**APPENDIX VI
PUBLIC SUMMARY**

PUBLIC SUMMARY

Figure VI-3. Collective doses (person-Sv) from routine truck transportation.

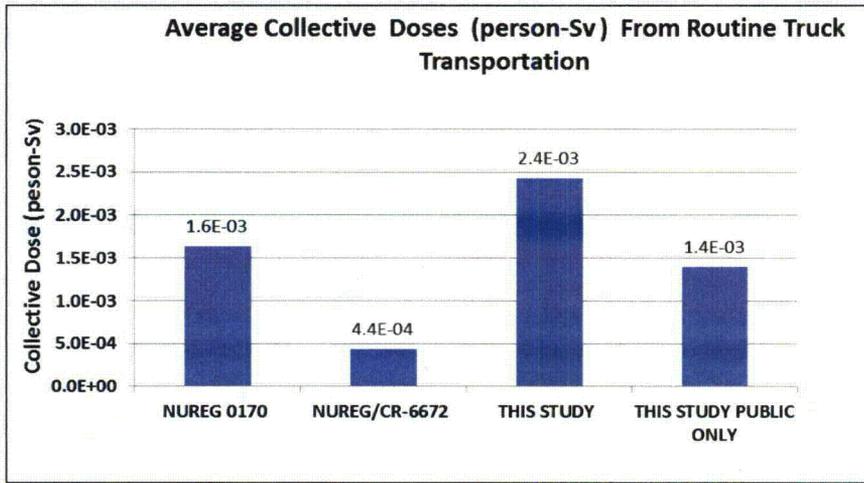
- Comment [JRC4]: Wrong figure!
- Moved (insertion) [1]
- Deleted: Figure PS-2.
- Moved up [1]: Collective doses from background and from a truck shipment of spent nuclear fuel (person-Sv).
- Deleted: approximately the same
- Deleted: and for this study, and are about 40 percent of the doses reported in
- Deleted: Figure PS-3
- Comment [JRC5]: delete
- Deleted: and
- Comment [JRC6]: delete
- Deleted: (Sprung et al., 2000)
- Deleted: and
- Deleted: densities are
